ARCHITECTURAL REVIEW BOARD
CITY OF FREDERICKSBURG, VIRGINIA
AGENDA
January 13, 2020
7:00 P.M.
COUNCIL CHAMBERS, CITY HALL

TO: ARCHITECTURAL REVIEW BOARD
FROM: Kate Schwartz, Historic Resources Planner
DATE: January 8, 2020 (for the January 13, 2020 hearing)
SUBJECT: Certificate of Appropriateness for exterior alteration at 1311 Caroline Street

TO: ARCHITECTURAL REVIEW BOARD
FROM: Kate Schwartz, Historic Resources Planner
DATE: January 8, 2020 (for the January 13, 2020 hearing)
SUBJECT: Certificate of Appropriateness for accessory structure at 1114-1118 Caroline Street

C/1 EAST ELEVATION - Sign Location
SCALE: NTS

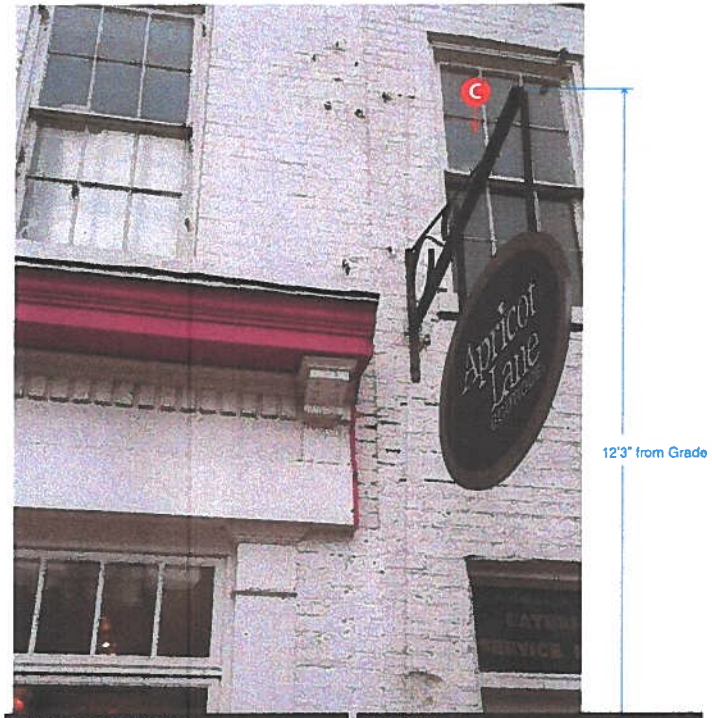
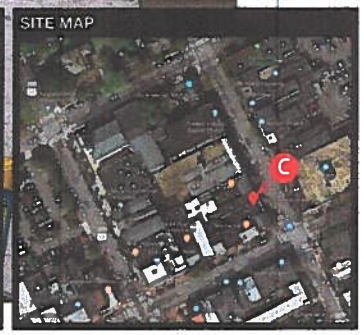
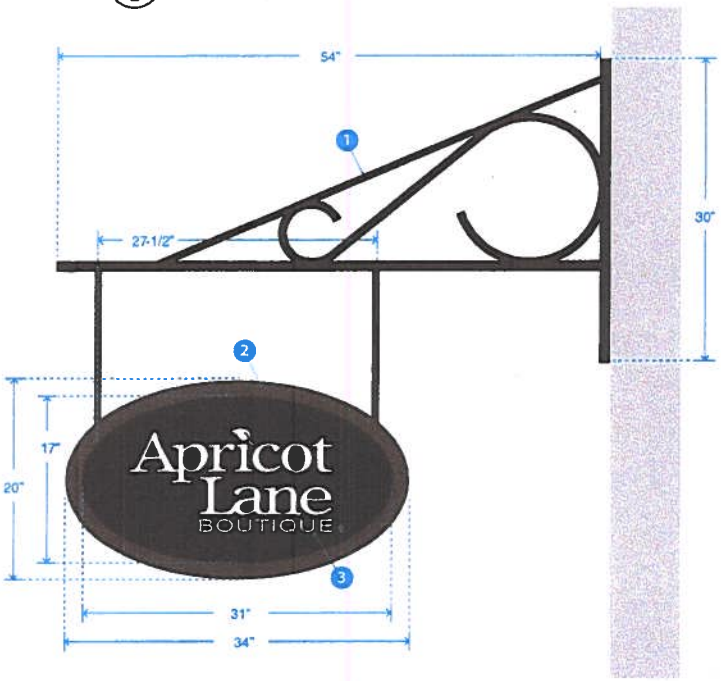
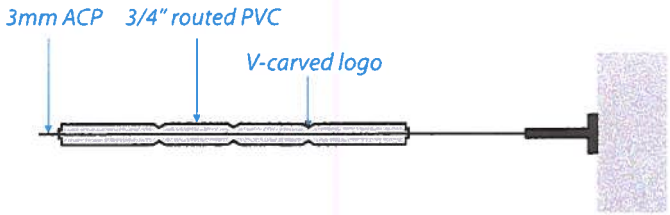
Two signs will be installed for the Apricot Lane Boutique retail business at this location. One oval-shaped projecting sign will hang from the existing iron bracket at the right side of the storefront. The scrolled metal bracket projects out 54 inches from the face of the building. This is greater than the projection permitted by the City Code, but is allowed to remain as an existing condition. The routed PVC sign is 20 inches tall by 34 inches wide, and approximately nine feet of clearance will be provided between the sidewalk and the bottom of the sign. Individually-mounted, High Density Urethane letters will also be mounted on the wood signboard area centered above the paired entry doors. This sign will be 11 and 3/8 inches in height and eight feet seven inches in length. The total area of the signs proposed is 12.8 square feet, which is within the allowance of 41 square feet for this building. The proposed signs are compatible with the character of the site and will not adversely impact any historic features.

RECOMMENDED ARB ACTION:
Approval of the certificate of appropriateness for the request as submitted.

acrylic on wood. Installed by 80M Signs.

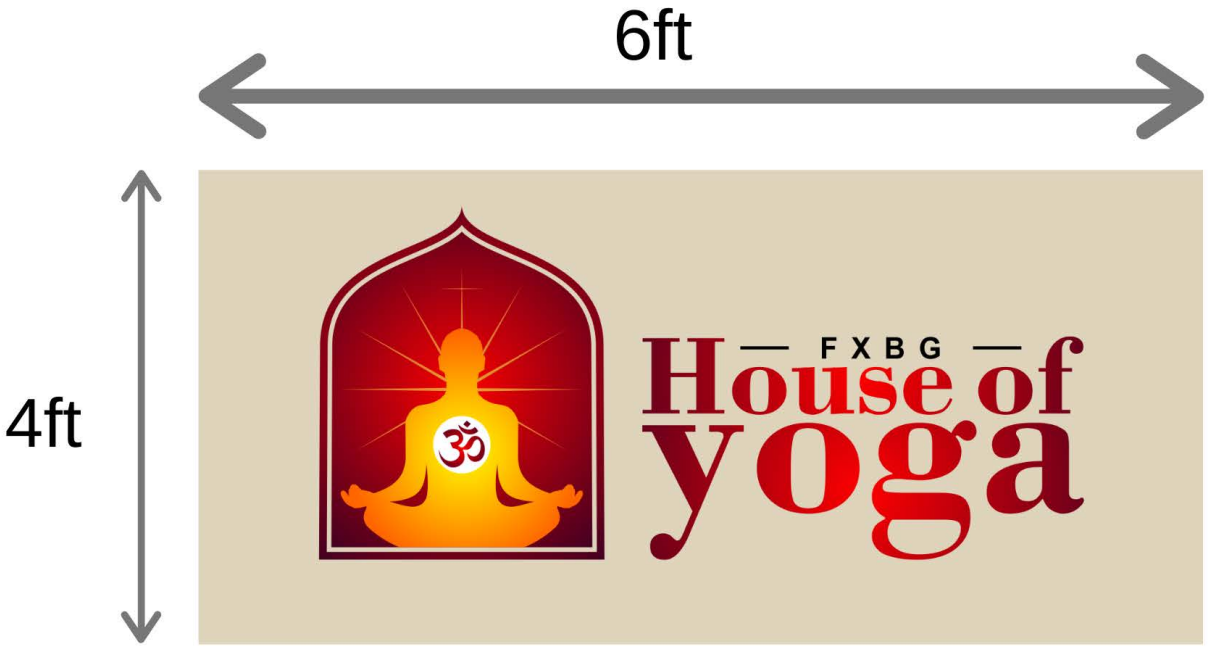
The applicant proposes to install one new building-mounted sign for a yoga studio in the second-floor space at this commercial property. The sign will be constructed of an acrylic panel on a wood base, six feet wide by four feet tall. The sign will be mounted to the brick and block wall at the west side of the property. The proposed sign accounts for 24 square feet of sign area. The total sign allowance for this building, which is shared with another tenant, is 63.75 square feet. The two businesses together will have signs accounting for 57 square feet. The proposed sign is compatible with the character of the site and the district.

RECOMMENDED ARB ACTION:
Approval of the certificate of appropriateness for the request as submitted.

1311 CAROLINE ST. - Proposed New Steps

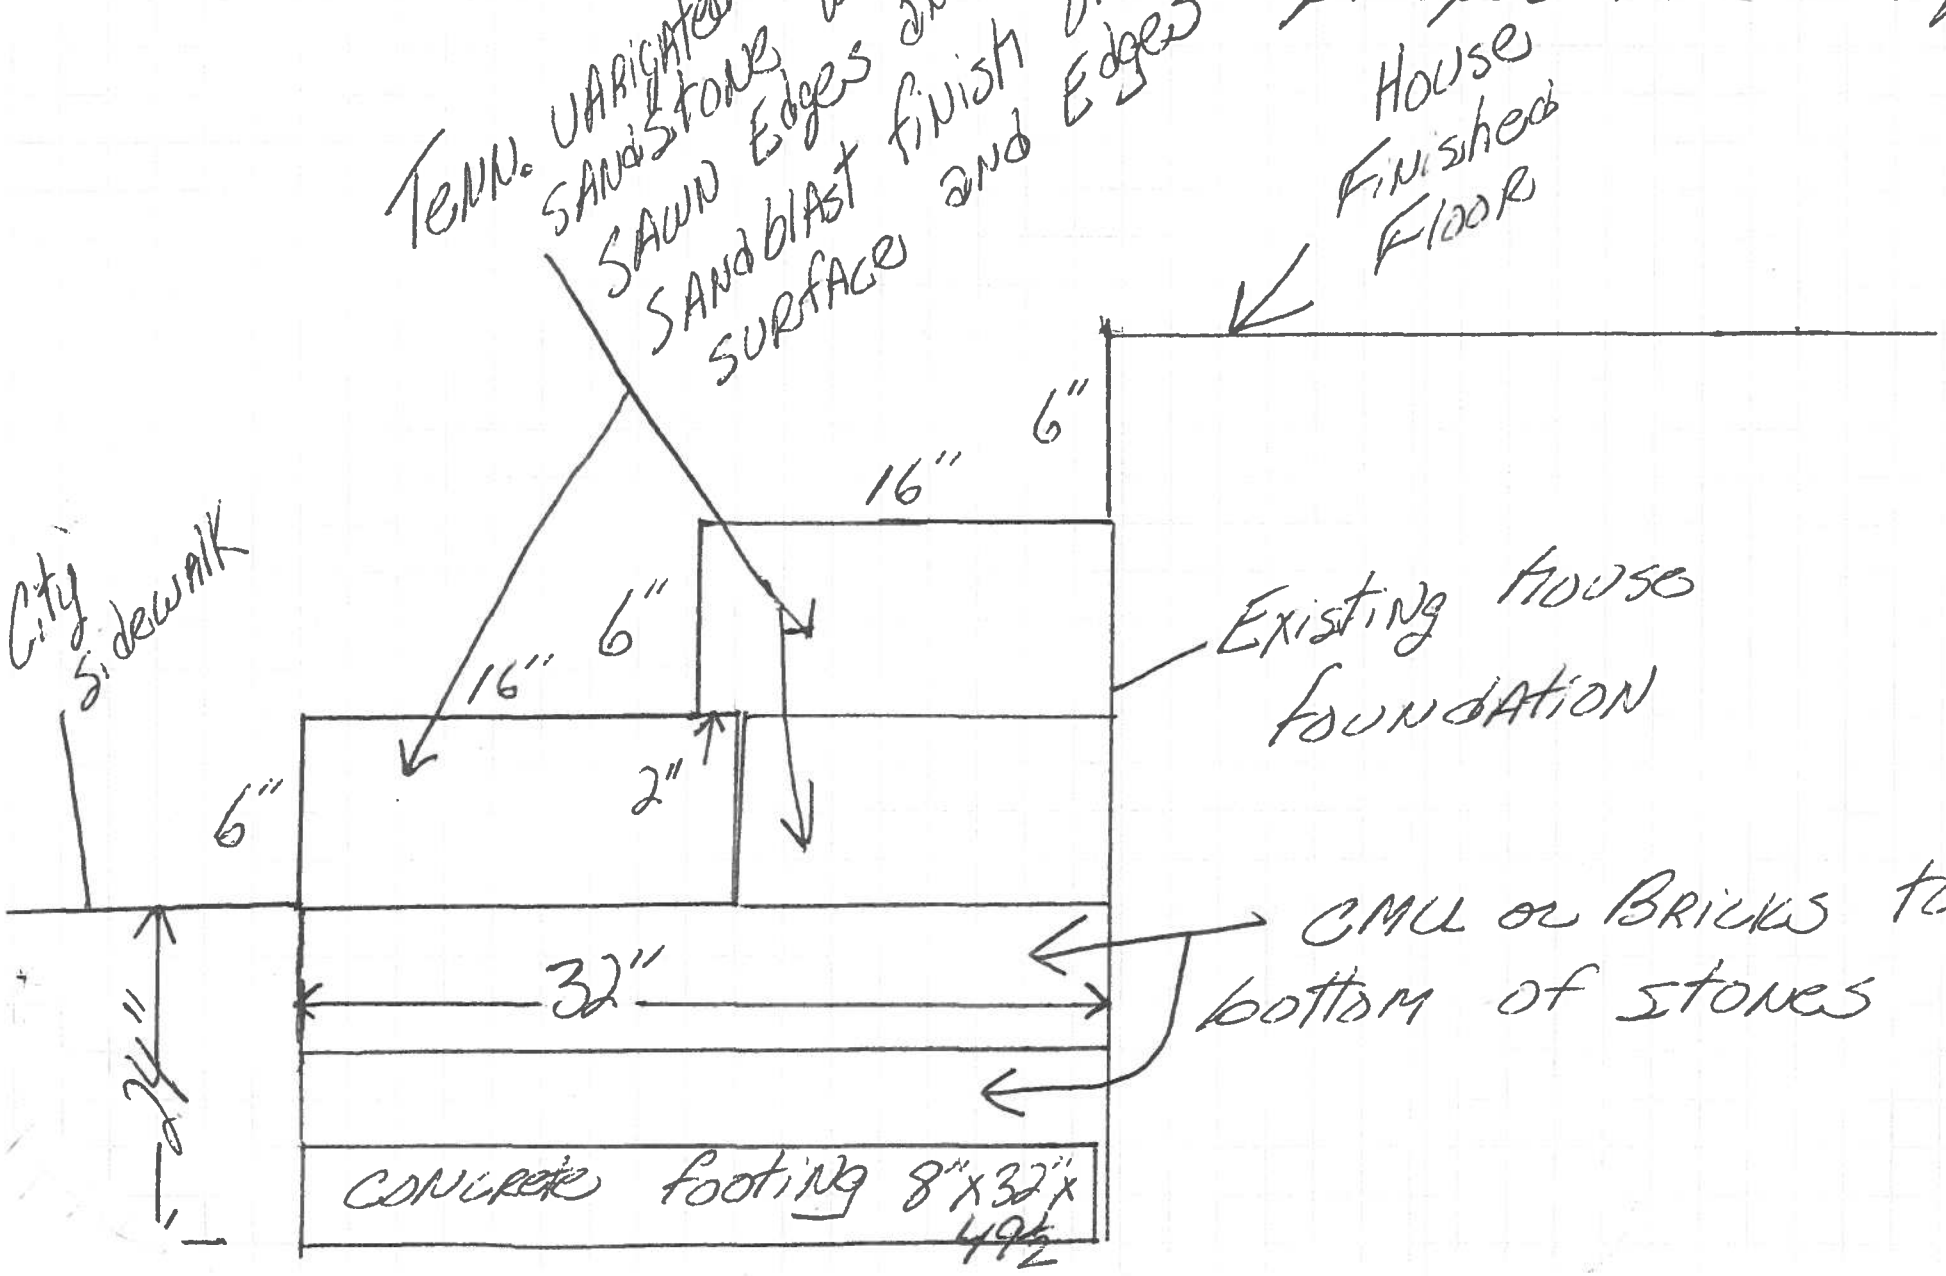
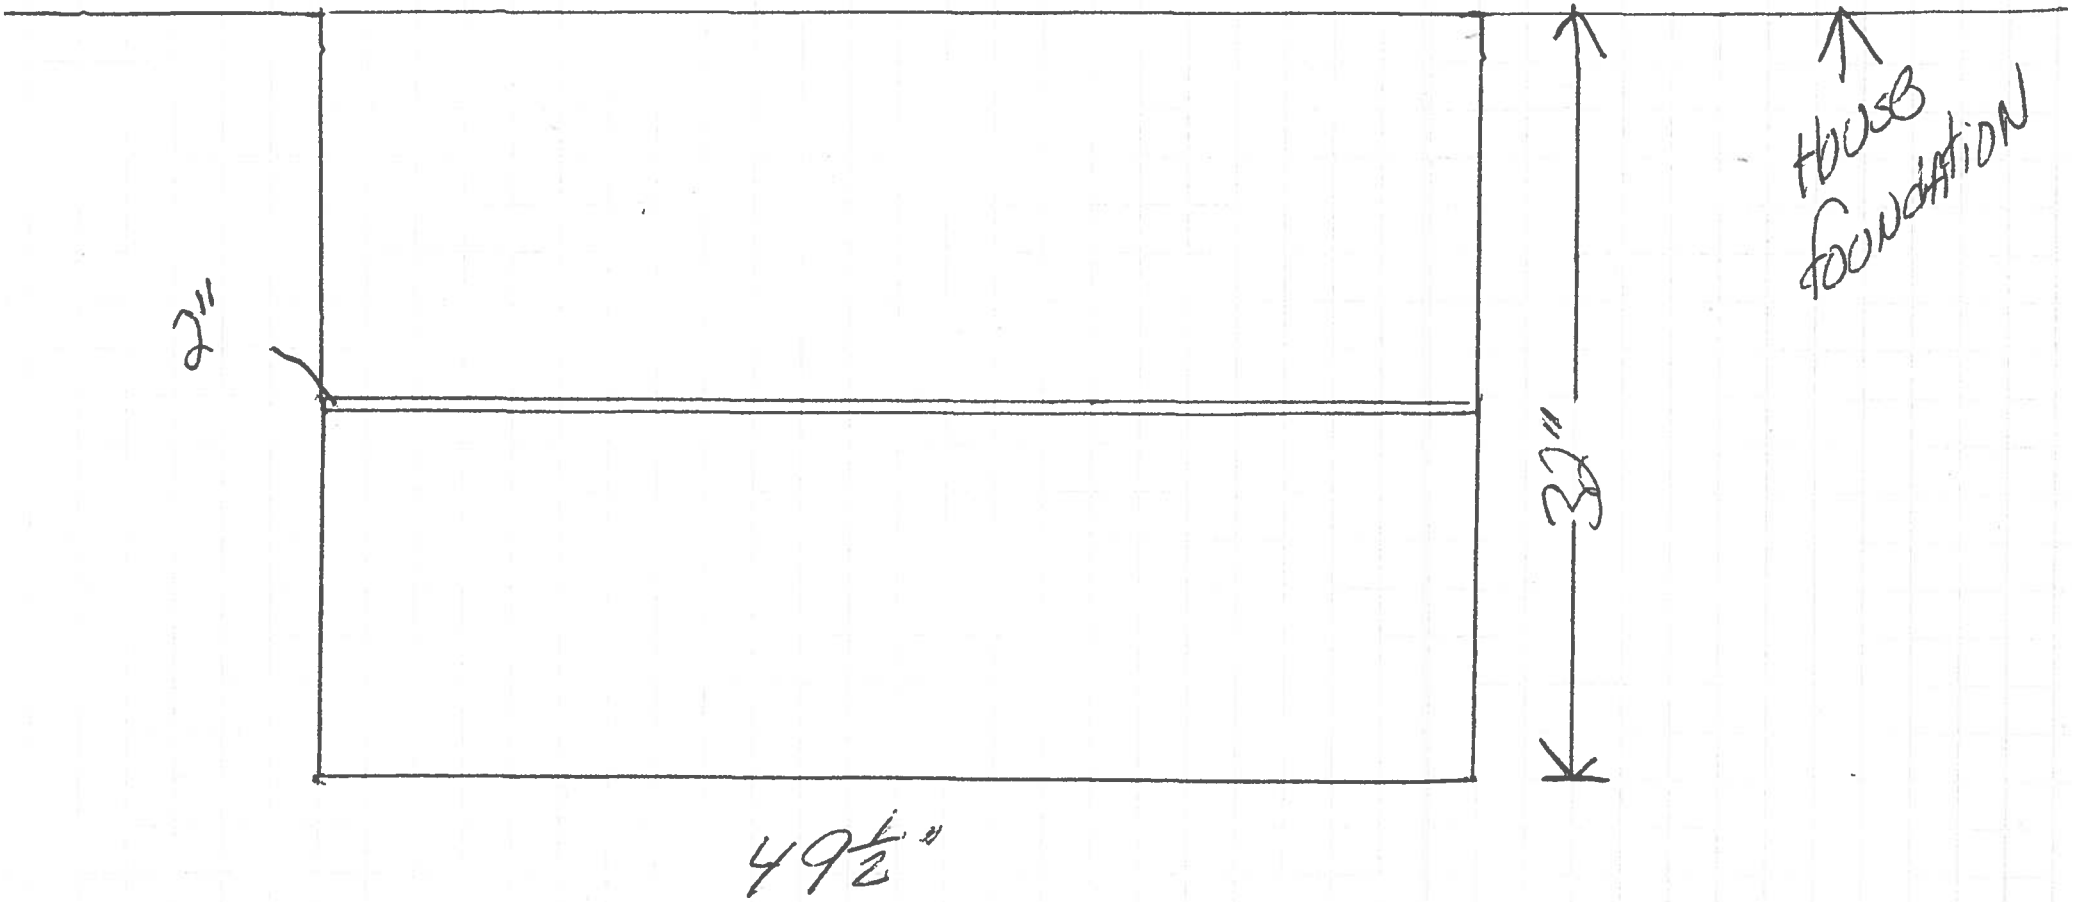
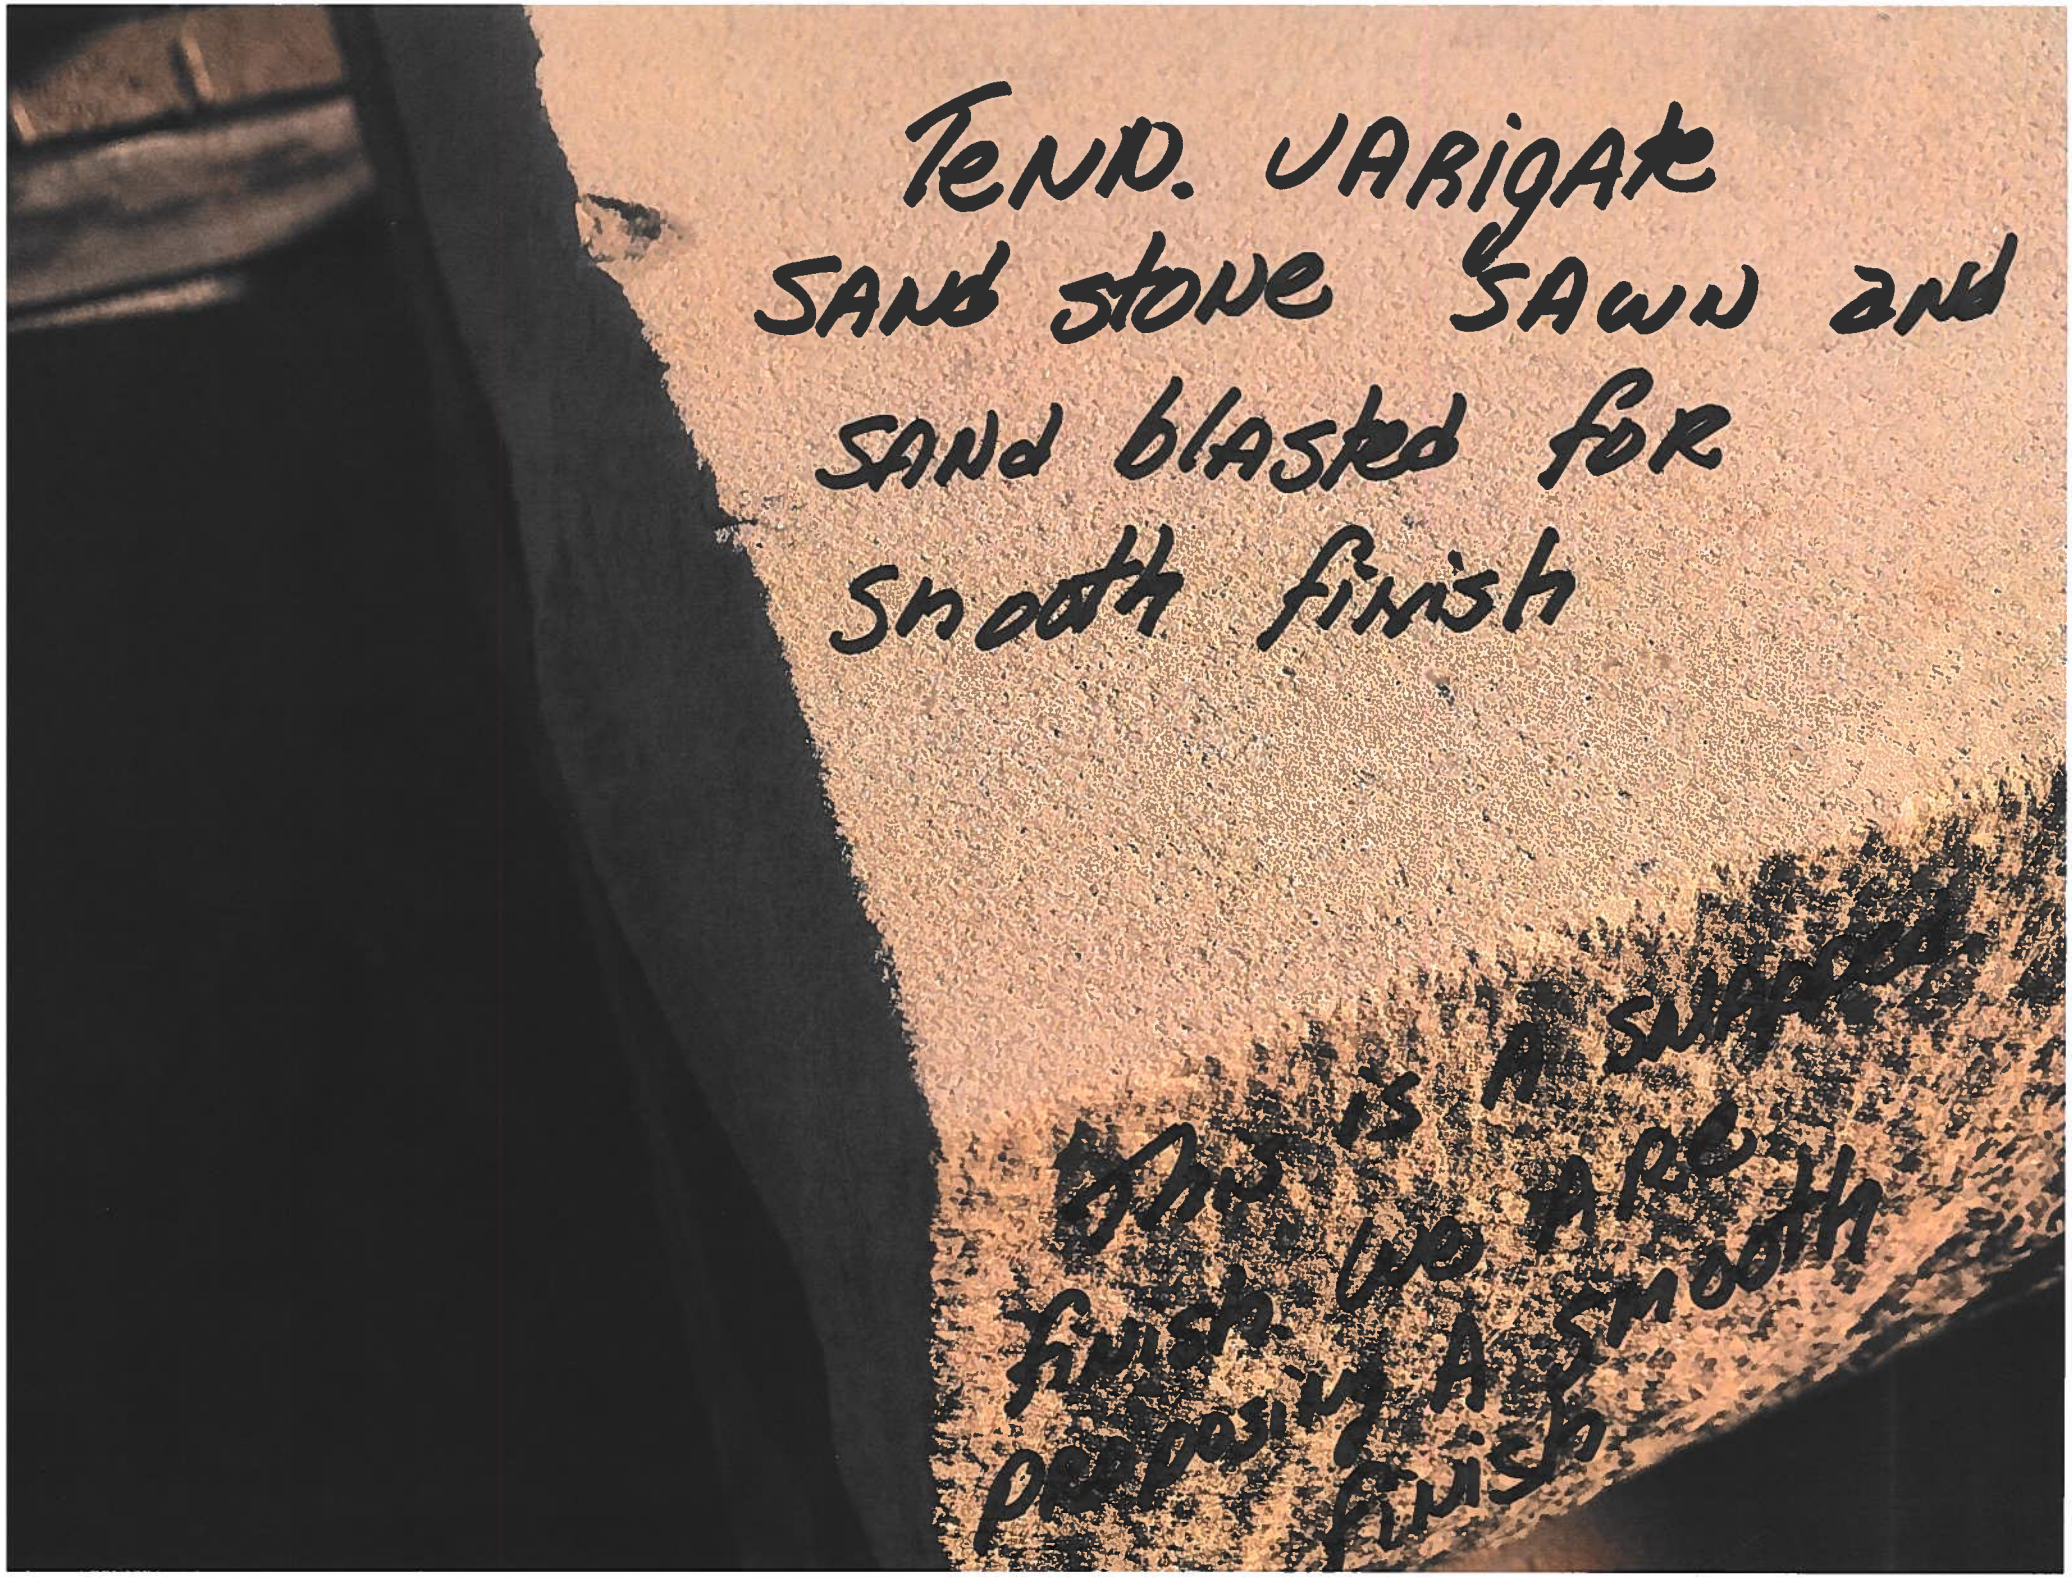
The applicant proposes to replace the single sandstone entry step that leads to the front door. The existing step is 8 ½ inches in height, with a 9 ½-inch elevation from the step into the house. The sandstone displays deterioration in the form of delamination, cracking, and erosion. For ease of access and safety, and due to the condition, the applicant proposes to remove the step and install two sandstone steps in its place. Two steps allow for an even six-inch rise at each step and into the house. The replacement material is variegated Tennessee sandstone, sawn and sand-blasted for a smooth finish.

The proposed replacement material closely matches the historic material and is appropriate for use. This alteration does not impact any character-defining features of the residence and will not affect its historic significance. Approval of the request as submitted is recommended.

Approval of the request for a Certificate of Appropriateness as submitted.
